Blair Creek Stream Mitigation Project

Year 1 (2022) Monitoring Report FINAL

Response to DMS Comments (January 19, 2023) for DRAFT Monitoring Year 1 Report.
Blair Creek Stream Mitigation Project, Clay County
Hiwassee River Basin: 06020002
DMS Project #100047 DEQ Contract #7415

Figure 5. Wetland Monitoring Well Graphs

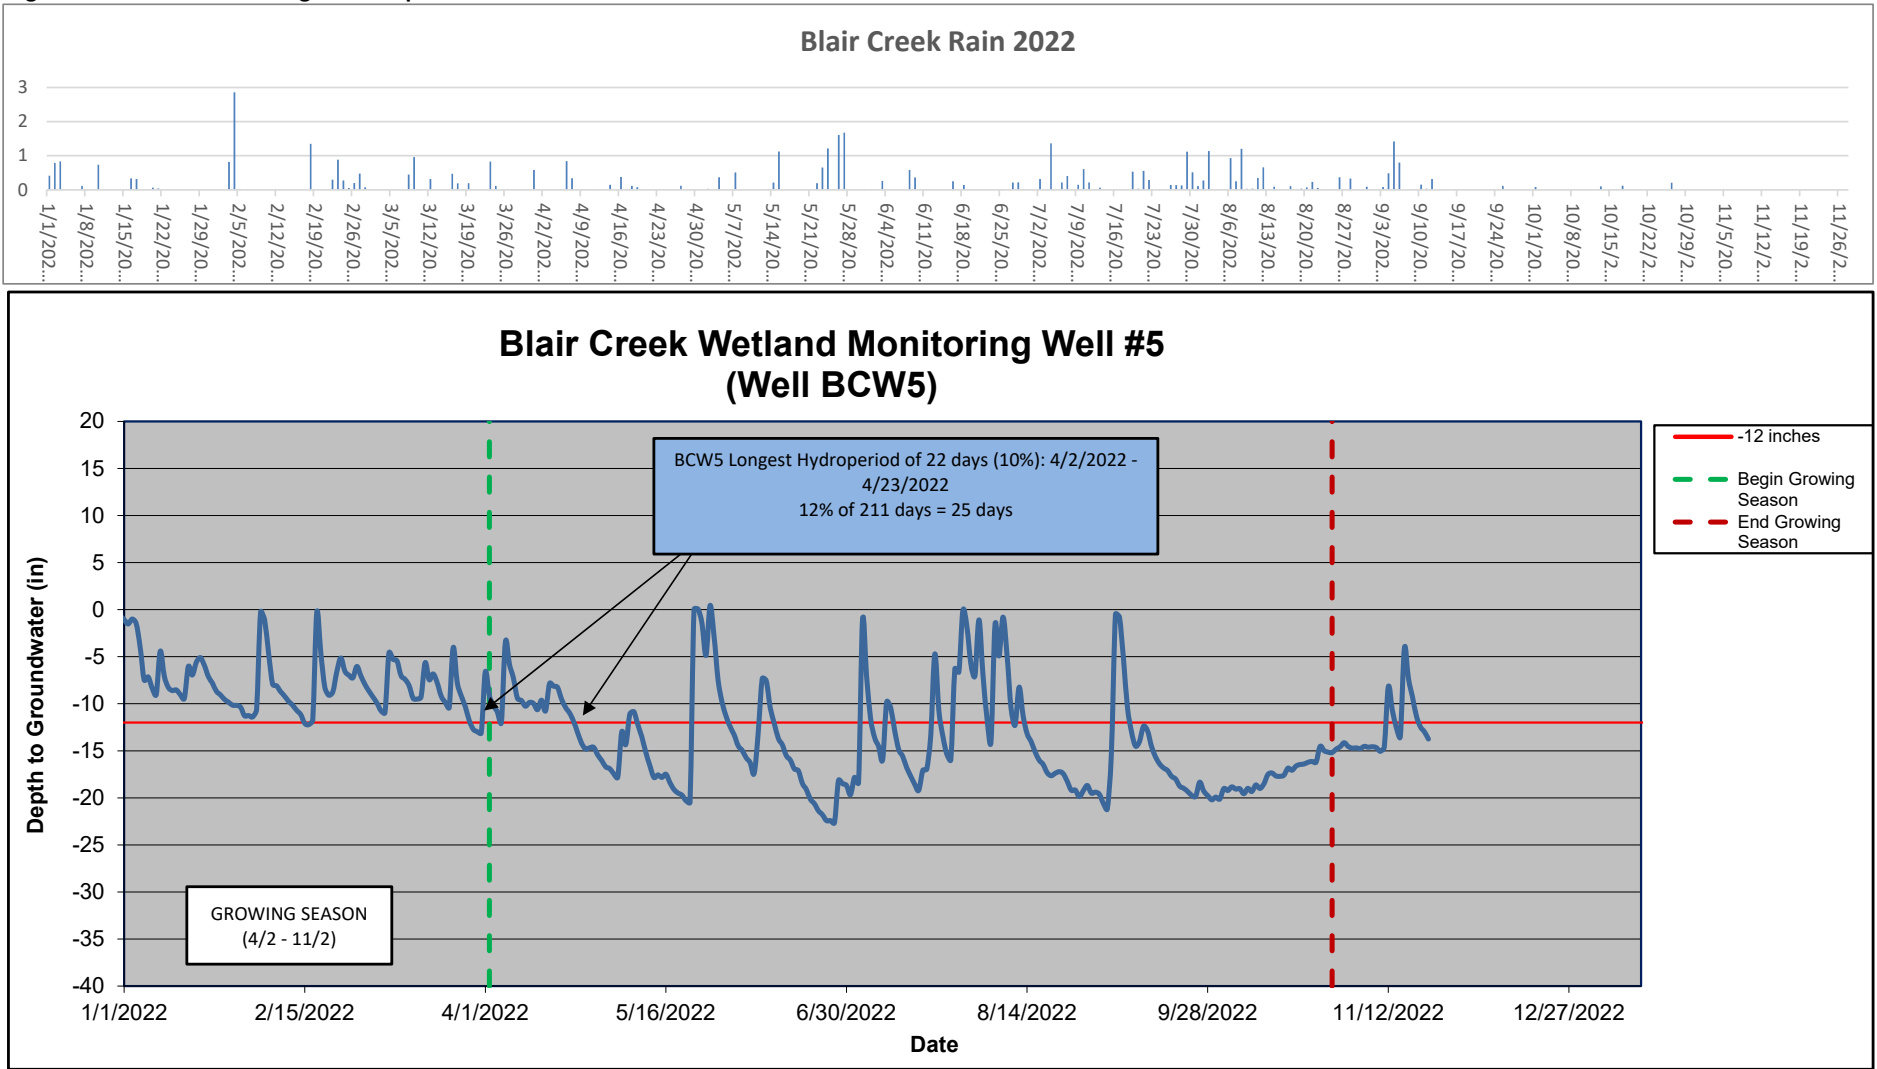
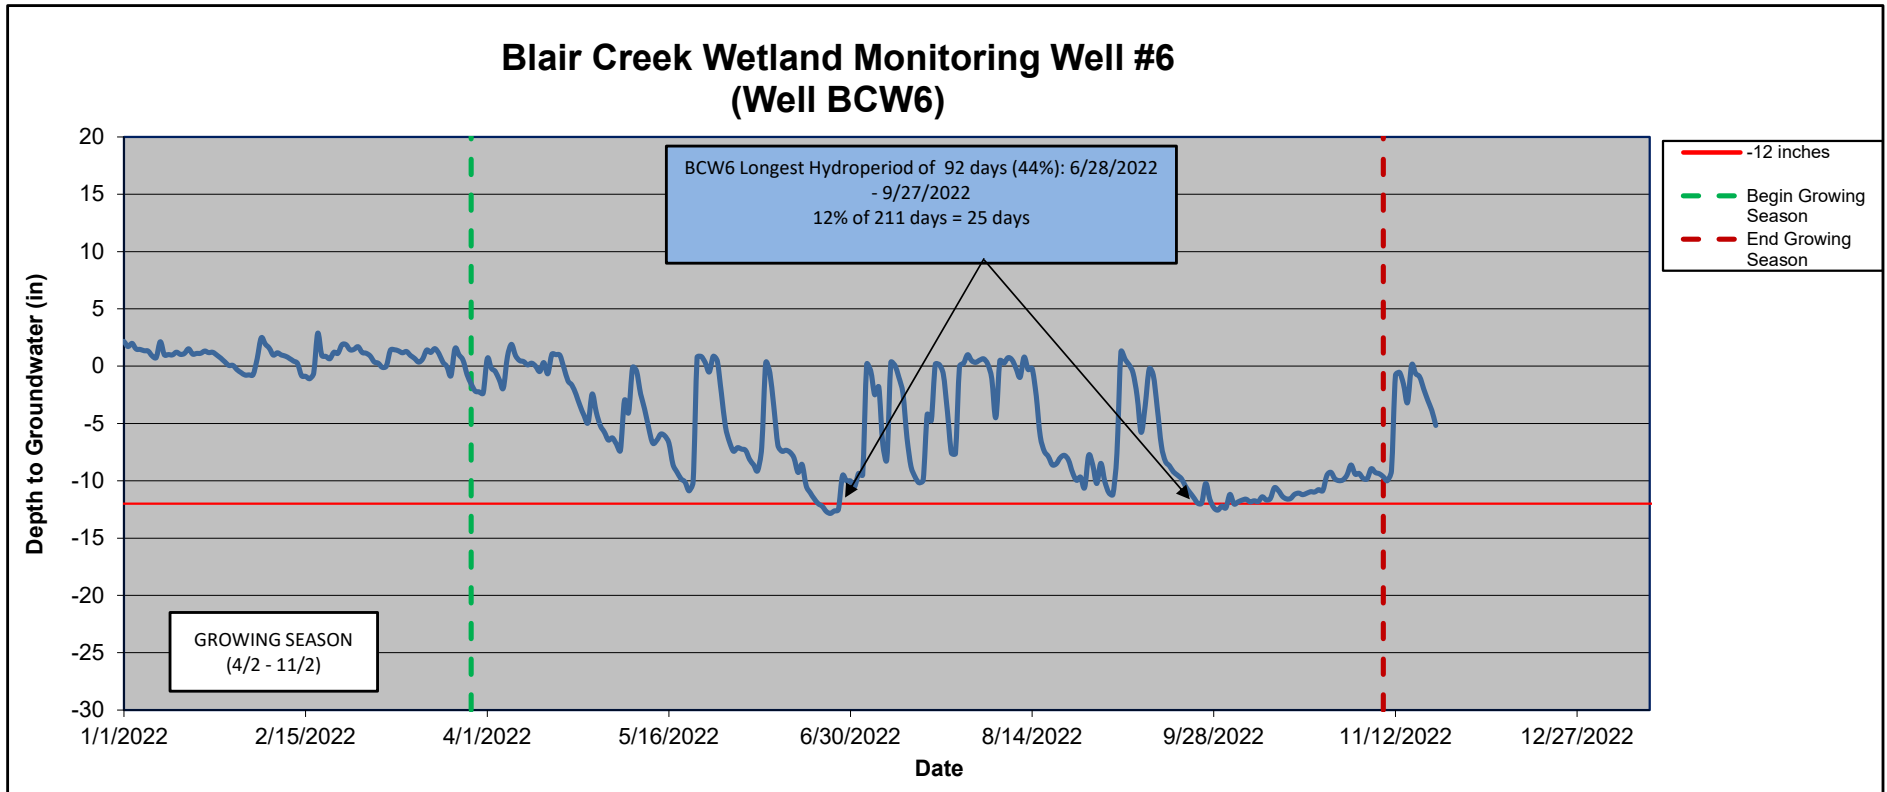
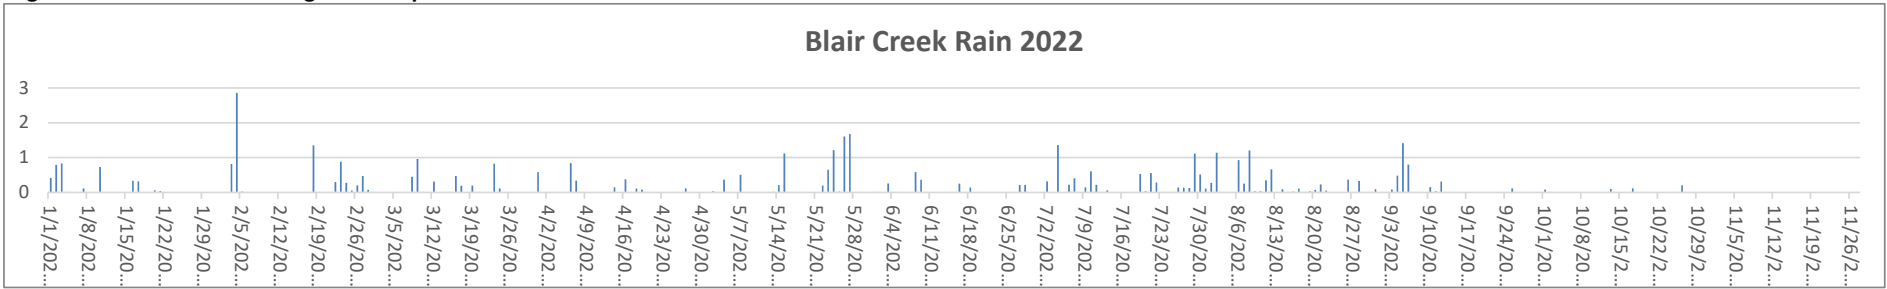
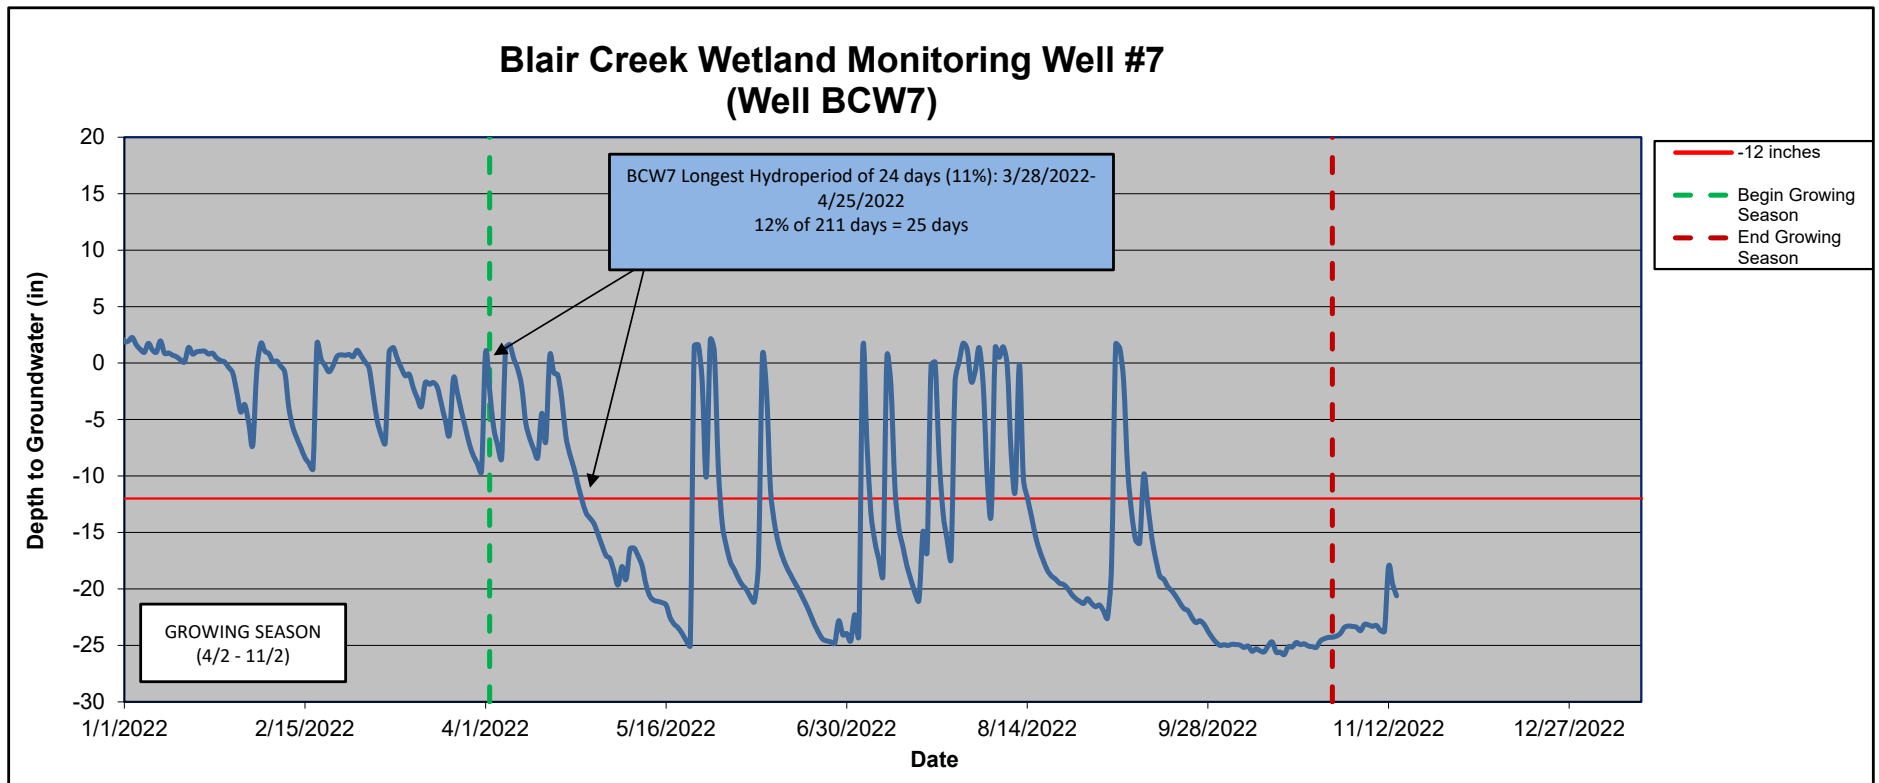
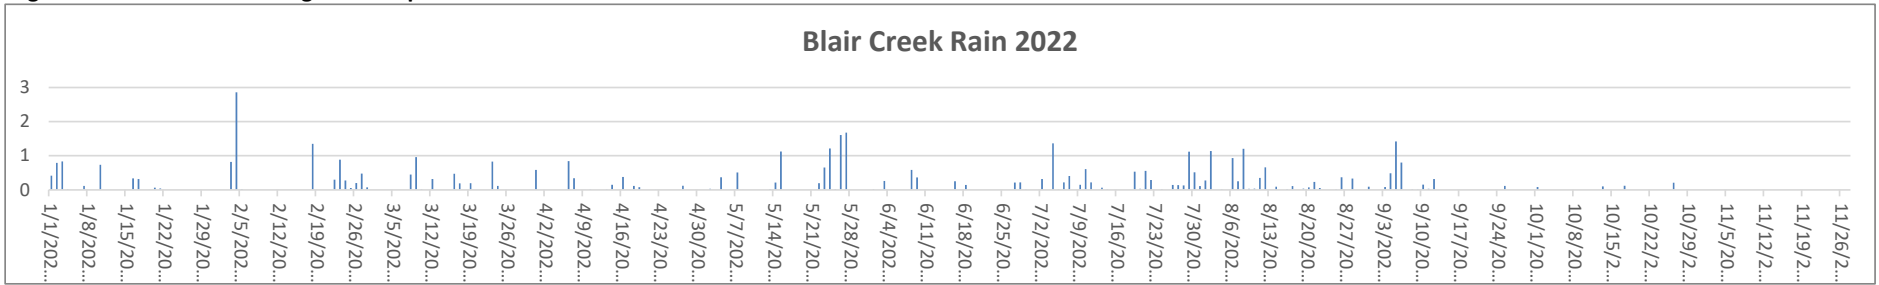
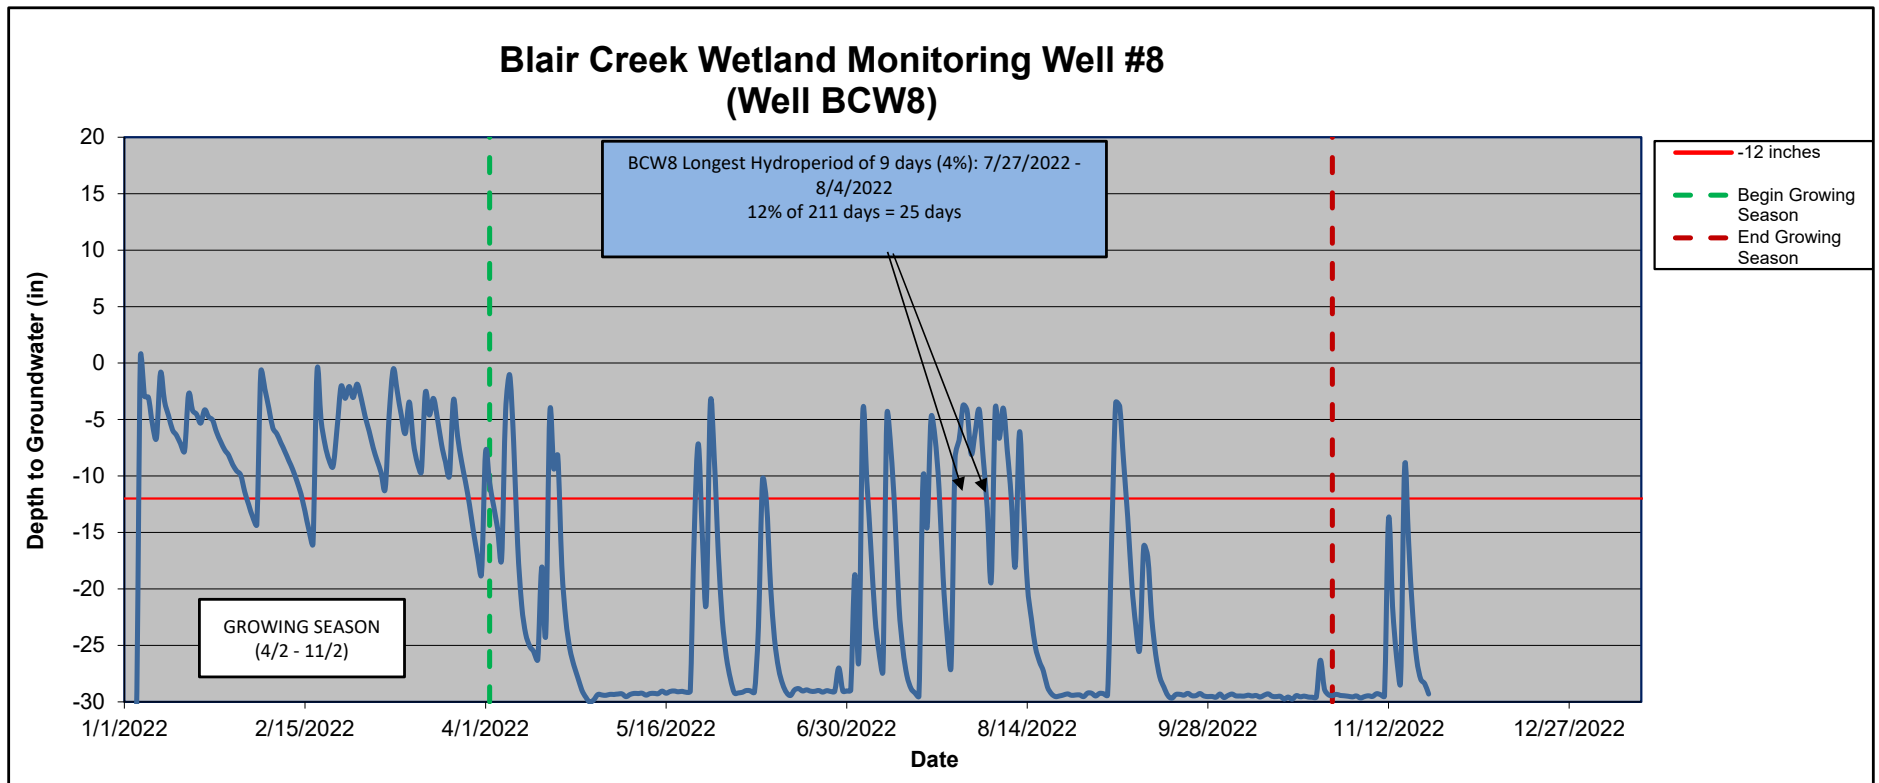
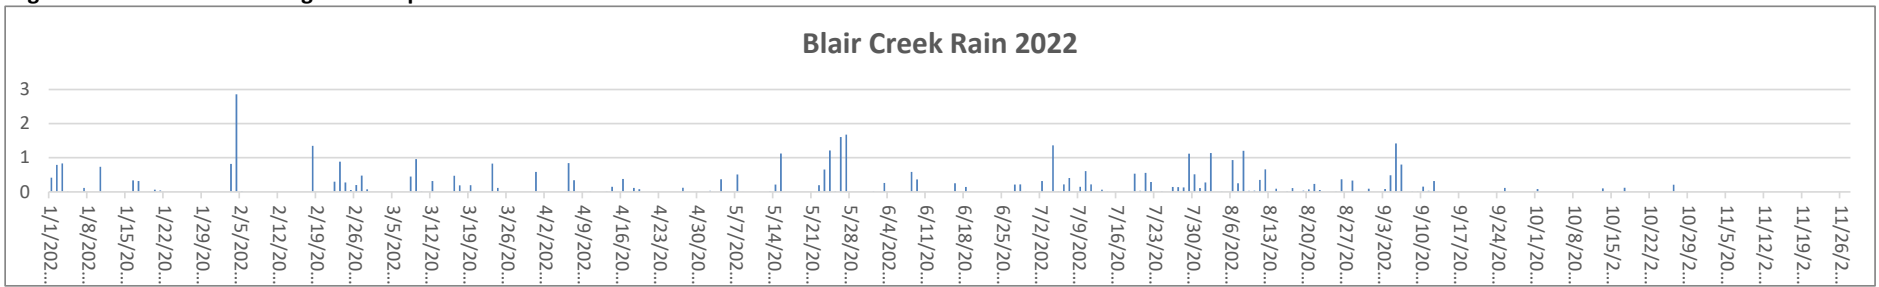
- Wetland gauge data was not included with draft digital deliverables. Please include raw data and spreadsheets used to produce figures with final submittal.

RESPONSE: *Wetland gauge data has been included in the electronic submission files as requested.*
